SOURCE: CHAIRMAN OF THE SPECIALISTS GROUP ON CODING FOR VISUAL TELEPHONY  
TITLE: REPORT OF THE EIGHTH MEETING IN SAN JOSE (MARCH 10-13, 1987)

### Annex 3 UPDATE OF FLEXIBLE HARDWARE SPECIFICATION

Figure 1 Adaptive quantizer structure

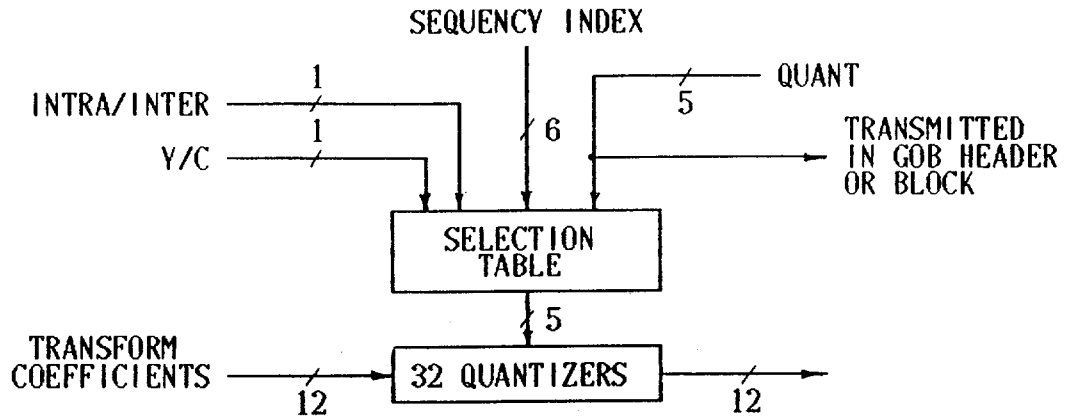
A small group consisting of members from UK, FRG, France, Japan, Netherlands has discussed Doc. #206 and Doc. #187. The principle of adaptive quantization as described in Doc. #187 and depicted in Fig. 1 below can be adopted. One of 32 quantizers may be assigned as a function of the sequency index, luminance/chrominance and intra/inter mode. This means that the quantizers and selection table are to be optimized in the flexible hardware.

Fig. 10

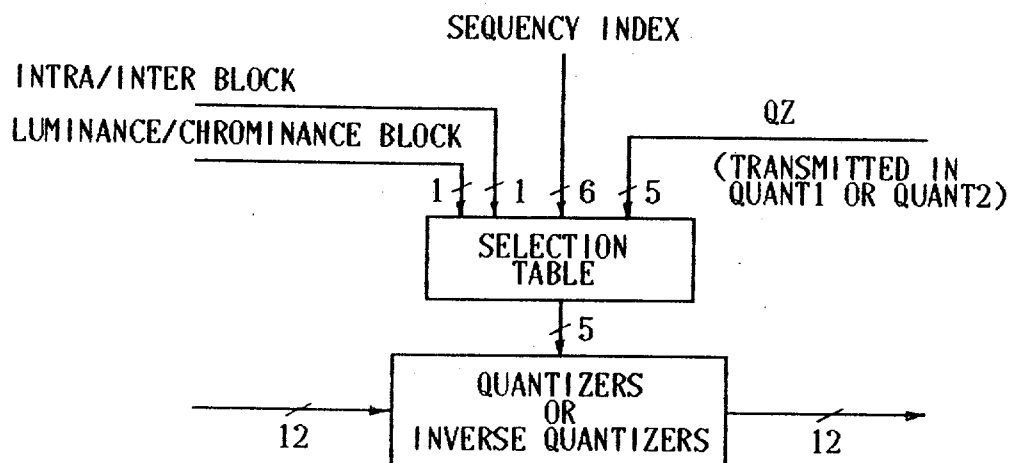
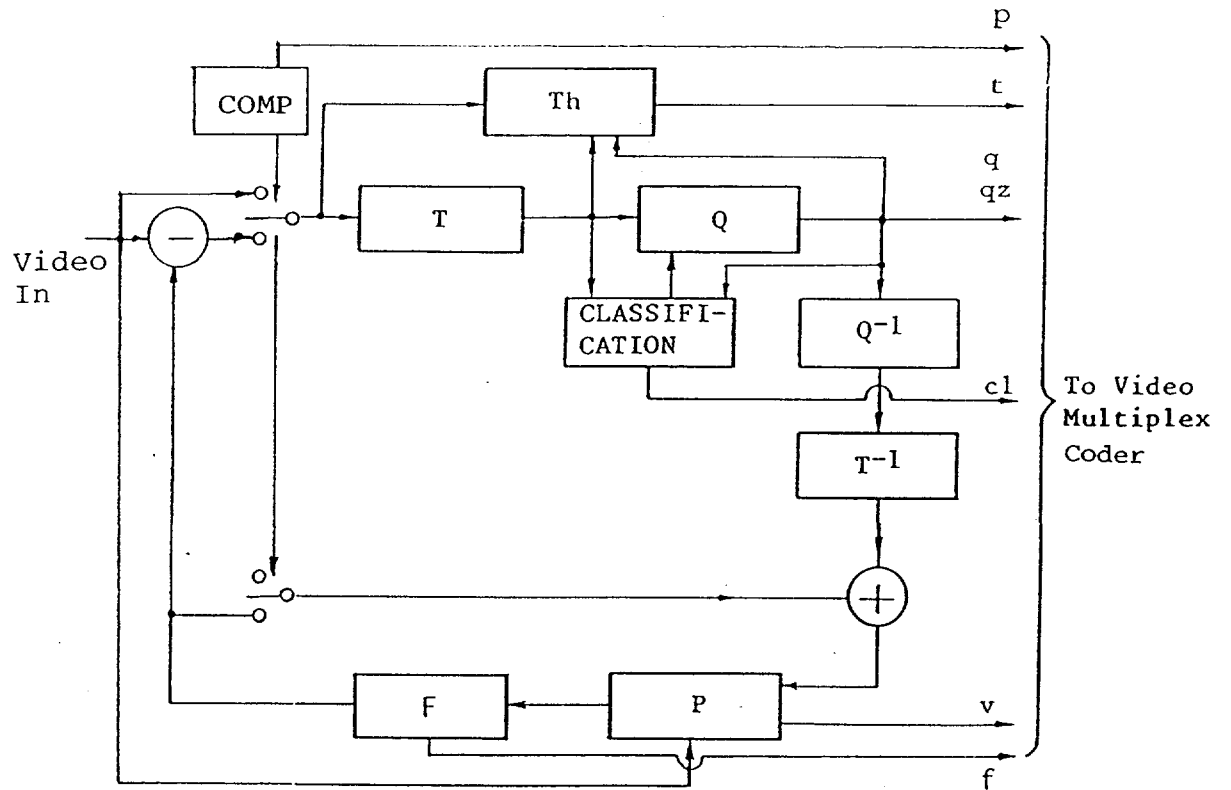
New Figure 10 concerning quantizer selection table is added.

"The number of inverse quantizers in the decoder shall be 32, each of which is programmable and has up to 12 bits input and 12 bits out. One of the 32 characteristics may be assigned as a function of quantizer indicator (QZ of Figure 4), sequency index, luminance/chrominance block and intra/inter mode. See Figure 10. Quantizer characteristics and selection function table are for further study."
